Attachment M – Detailed Response to Submissions Table

Attachment M – The Children’s Hospital at Westmead – Paediatric Services Building (SSD- 10349252) – Detailed Response to Submissions Table

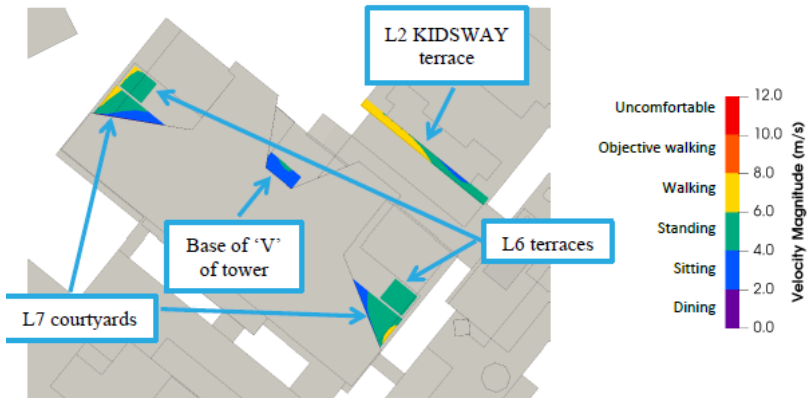
3	<p>Construction Hours</p> <p><i>Detailed justification is to be provided for any works proposed outside of recommended construction hours. If works outside of recommended construction hours are proposed, a works plan must be included to detail how often works would occur outside the recommended times, the activities permitted and the period of time these works would continue.</i></p>	<p>The construction of the proposed PSB is expected to occur during the following hours:</p> <ul style="list-style-type: none"> – Monday to Friday: 7am to 6pm; and – Saturday: 8am to 5pm. <p>Under the NSW DEC Interim Construction Noise Guideline, out of hours work (OOHW) may be undertaken outside of the recommended standard hours for 'public infrastructure works that shorten the length of a project and are supported by the affected community'.</p>

Comment in submission	Applicant's response
	<p>The proposed PSB is identified as public infrastructure works. Note that the standard construction work hours on Saturdays are between 8am to 1pm, and the proposed PSB construction work hours on Saturdays are between 8am and 5pm.</p> <p>An updated acoustics assessment has been undertaken to assess potential impacts of the proposed OOHW. Refer to Attachment L.</p> <p>The results of the noise and vibration impact assessment are summarised below:</p> <ul style="list-style-type: none"> – The ICNG recommends a more stringent criteria for construction works conducted outside standard working hours for residential receivers. The nearest external resident receiver (R1) has been assessed against both the standard hours and the OOHW and no exceedances are predicted. – The surrounding residential receivers respectively R1 and R2 are located approximately 140m and 500m from the construction site. These distances eliminate the risk for any vibration impact. In terms of noise the closest receiver R1 is also shielded by Kids Research for all the early works period which will be typically the noisiest construction activities including the piling of the foundations and all inground services set out. – The newly completed CASB located adjacent to the proposed PSB was constructed with allowances for work to be conducted outside of Standard hours (similar to the requested hours for the PSB) which was successfully delivered and completed. <p>All these factors considered clearly indicate that the risks for noise and vibration impact associated with conducting construction works outside of standard hours on the surrounding community and adjacent occupant of surrounding buildings are minimal. The only deviation from standard hours is for Saturday afternoons, where works will continue until 5pm, where the INCG suggests they terminate at 1pm. No works are planned on evenings or Sundays as is normal practise, and to provide affected receivers with respite. It is noted that the City of Parramatta Council permits construction works on a building site on Saturdays from 8am to 5pm. The proposed construction hours for the PSB comply with these hours.</p> <p>Given the OOHW will result in no exceedances of noise criteria to surrounding sensitive receivers, and the works are for public infrastructure which will shorten the construction timeframes of the project and therefore limit duration of project to the surrounding community, it is considered a works plan is not required.</p>

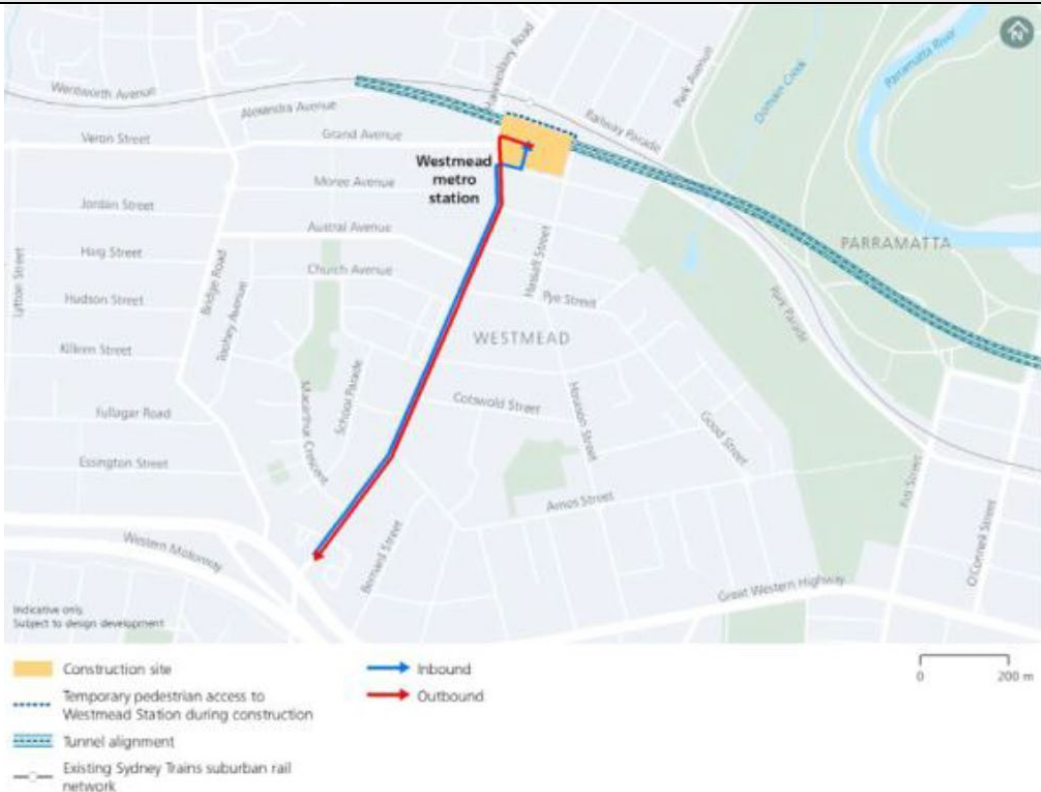
<p>5 Construction management</p> <p><i>Provide details of how the work area in which construction parking is proposed will integrate with existing/proposed parking.</i></p>	<p>Parking for construction workers may be established within the construction site boundary only. These will be separate areas not integrated with existing/proposed parking. Workers would not be permitted to park outside of the construction site.</p> <p>This presents an opportunity for the contractor to encourage carpooling and implement measures that minimise the number of workers who would arrive during the AM and PM peak periods for the precinct and also the broader road network.</p> <p>The appointed contractor will be responsible for adhering to the above parking objectives in consultation with Health Infrastructure and SCHN.</p>
<p>6 Architectural and landscape plans</p> <p><i>Visual perspectives are to be provided detailing the pedestrian connections and view corridors from the pedestrian scale.</i></p>	<p>Visual perspectives have been included in the Architectural Design Statement Addendum at Attachment B, and at Figure 1 and Figure 2.</p> <p>These perspectives provide views from a pedestrian scale from two (2) locations:</p> <ul style="list-style-type: none"> – View 1: From the entrance from Hawkesbury Road viewing KIDSPARK; and – View 2: From Redbank Road.

Comment in submission	Applicant's response
	 <p data-bbox="1012 818 1724 866">Figure 1 View 1: The entrance from Hawkesbury Road viewing KIDSPARK. Source: Billard Leece Partnership Architects</p> <p data-bbox="1012 898 2027 986">The entry from Hawkesbury Road provides direct visual connection to the KIDSPARK with retail pod 4 (left) and retail pod 2 (right) in the foreground, and the PSB beyond. The entry is flanked with locally native planting beneath deciduous canopy trees to each side.</p>

Comment in submission	Applicant's response
	 <p data-bbox="1014 882 1429 927">Figure 2 View 2: From Redbank Road Source: Billard Leece Partnership Architects</p> <p data-bbox="1014 983 2033 1074">Taken from a pedestrian perspective on Redbank Road, this visual demonstrates the PSB in the background, and the existing trees and vegetation planted along Redbank Road in the foreground.</p>
<p data-bbox="159 1098 613 1121">7 Architectural and landscape plans</p> <p data-bbox="221 1145 815 1169"><i>Updated landscape plans are to be submitted providing:</i></p> <ul style="list-style-type: none"> <li data-bbox="271 1193 954 1249">a) <i>further detail of the aboriginal garden and its integration with the Kid's Way.</i> <li data-bbox="271 1273 904 1361">b) <i>details of the outdoor levels and enclosed outdoor level landscaped areas and their treatment and access arrangements.</i> 	<p data-bbox="1014 1098 2007 1249">a) The Aboriginal Garden is located adjacent the main entrance to the PSB and adjacent the internal meeting room for the Aboriginal community. The detailed design of the garden will be undertaken in collaboration with Aboriginal stakeholders. Refer to the updated KIDSPARK Landscape Concept Design Plan at Figure 3 for the revised location of Aboriginal Garden.</p>

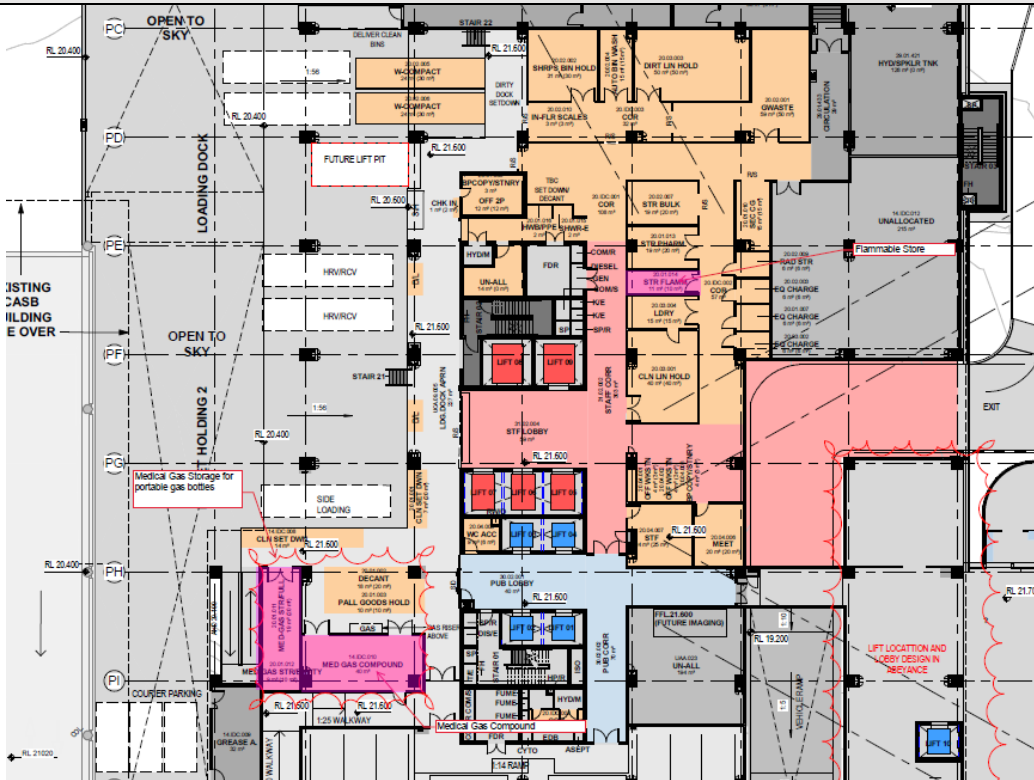
Comment in submission	Applicant's response
		<ul style="list-style-type: none"> – A Contextual Response to Parramatta River and surrounds – Connection to Country through the use of natural colours and textures – A Reflecting Place by Reflecting Nature – materials and colours working harmoniously with the landscape design – Characteristics of the River and the Riverbank – materials, colours, and ephemeral qualities of the river
10	<p>Wind</p> <p><i>Provide further detail of the pedestrian comfort levels for each landscape terrace on the multiple levels of the PSB.</i></p>	<p>The PSB external terraces/courtyards at the following locations have been assessed for pedestrian comfort and safety at:</p> <ul style="list-style-type: none"> – Level 02 KIDSWAY terrace; – Level 06 accessible landscaped terraces (north and south); and – Level 07 courtyards (north and south). <p>From a comfort perspective, all areas of the terraces/courtyards are classified as suitable for walking or better, with the majority of areas classified as standing or sitting. The safety criterion is met for all terraces/courtyards. Refer to Figure 5 and Figure 6.</p>  <p>Figure 5 Classification of wind safety at 1.5m above local ground level – external terraces/courtyards Source: Arup</p>

Comment in submission	Applicant's response
		 <p>Figure 6 Classification of wind comfort at 1.5m above local ground level – external terraces/courtyards Source: Arup</p> <p>For further detail, refer to the revised Environmental Wind Assessment Report prepared by Arup at Attachment F.</p>
11	<p>Transport</p> <p><i>The cumulative construction impacts are to be further investigated and assessed, taking into consideration light rail works and concurrent building construction works.</i></p>	<p>It is expected construction of the PSB may coincide with construction of the Parramatta Light Rail (PLR) and Sydney Metro West.</p> <p>While construction vehicles will have origins and destinations from a wide variety of locations, construction vehicles are generally limited to the arterial road network, and dedicated construction vehicle routes are developed with the aim to provide the shortest distances to/from the arterial road network.</p> <p>The primary construction vehicle routes for the PSB are likely to include to/from north and east via Redbank Road and Briens Road and to/from south and west via Institute Road, Darcy Road and Cumberland Highway. Redbank Road would be the preferred route, as it provides a more direct access between the site and the arterial road network to/from the site from the north-east.</p> <p>These routes are shown below in Figure 7 and Figure 8.</p>

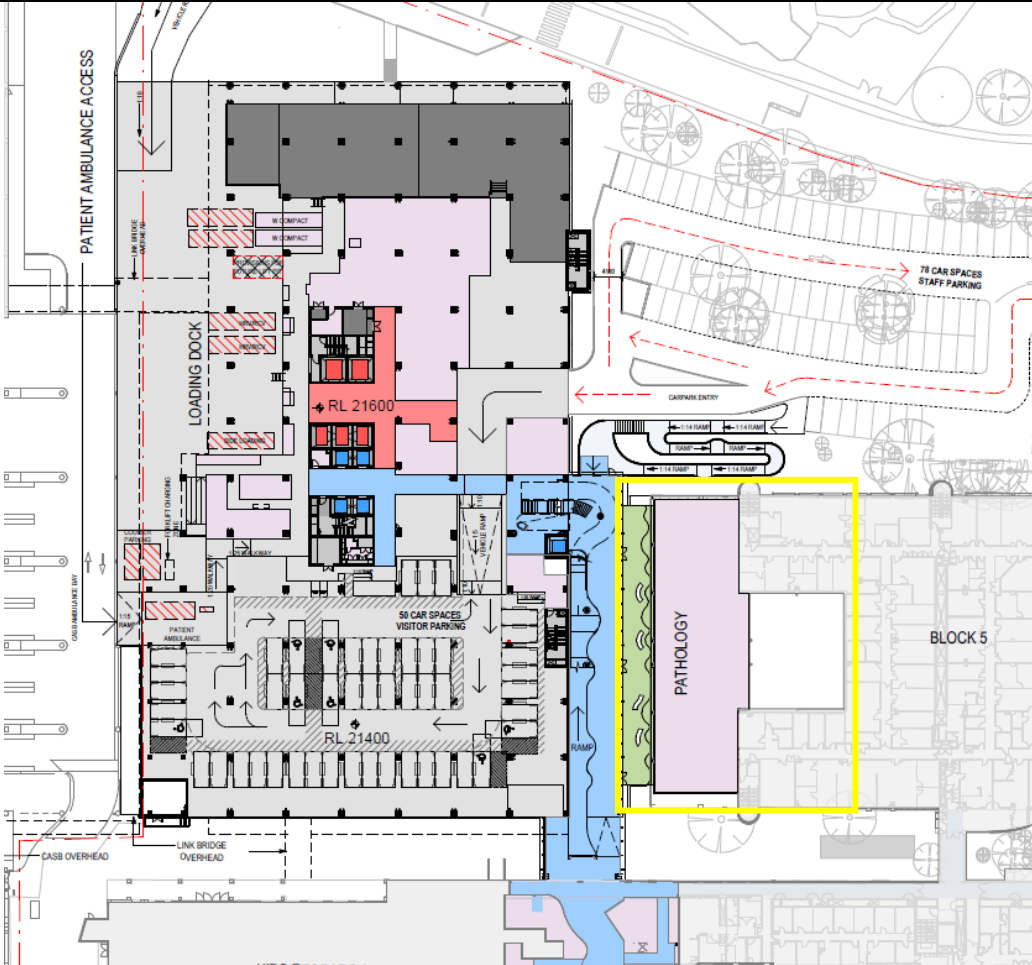
13	<p>Transport</p> <p><i>Identify whether any motorcycle parking is incorporated into the proposal and if so, the relevant architectural plans are to be updated accordingly to show the available parking.</i></p>	<p>Two (2) motorcycle parking spaces are included at Level 02 of the PSB, at the northern side of the car park, near the lift lobby.</p> <p>Motorcycle parking rates for the Parramatta City Centre have been adopted for the proposed PSB, requiring 1 motorcycle parking space for every 50 car parking spaces. The provision of two (2) motorcycle spaces complies with this rate.</p> <p>The proposed motorcycle parking spaces have been designed in accordance with Australian Standards, with dimensions of 1.2m wide by 2.5m long.</p> <p>Refer to the revised Architectural Plans at Attachment A.</p>
14	<p>Hazards</p> <p><i>Confirm the scope of dangerous goods storage for the PSB will only involve the installation of one new 15,000 Litre main liquid oxygen tank and one new 1,200 Litre backup liquid oxygen tank.</i></p>	<p>The Children's Hospital Westmead is currently serviced by a 15,000 L primary oxygen VIE tank and a 1,200L secondary VIE tank, located in the main gas compound off Redbank Road.</p> <p>The new building requires additional oxygen capacity beyond the current supply at the hospital. It was previously proposed to accommodate the new building with an additional 15,000 L primary oxygen tank and 1,500 L back-up tank and this was the arrangement analysed by Arup in the Preliminary Hazards Assessment report exhibited with the EIS. However, since this time the design has developed further and it is now proposed to remove the existing 15,000 L tank and 1,200 L back up tank with install larger tanks that will be able to accommodate not only the PSB, but the broader expansion of the hospital as part of the longer-term masterplan. As a result, the existing tanks will be replaced with a primary 48,000 L oxygen tank and a 5,000 L back up tank. Tanks of this size will allow for a constant fill level of around 20% with fortnightly replenishment.</p>

Comment in submission	Applicant's response
		<p>The primary oxygen tank will be located on the lower-level platform of the existing CHW loading dock, while the back-up tank will be located on the upper-level platform of the existing CHW loading dock.</p> <p>The transitional arrangement is for the 5,000 L back up vessel to be installed on the upper platform and commissioned to supply the hospital, before the existing vessels are removed, and the main supply tank is replaced. This will ensure the continuous supply of oxygen to the hospital during the installation of the new tanks. A revised Preliminary Hazard Analysis (PHA) has been prepared by Arup at Attachment J, and a Design Memo relating to the Gas compound prepared by Stantec at Attachment K. Both documents provide support and assurance for the revised arrangement.</p>
15	<p>Hazards</p> <p><i>Confirm that the two liquid oxygen tanks are to be located within the loading dock area located to the south of Redbank Road as indicated in drawing CHW-AR-DG-PSB-SSD00 Revision A..</i></p>	<p>It is confirmed that the liquid oxygen tanks will be located in the existing CHW loading dock. Refer to the Design Memo prepared by Stantec at Attachment K.</p>
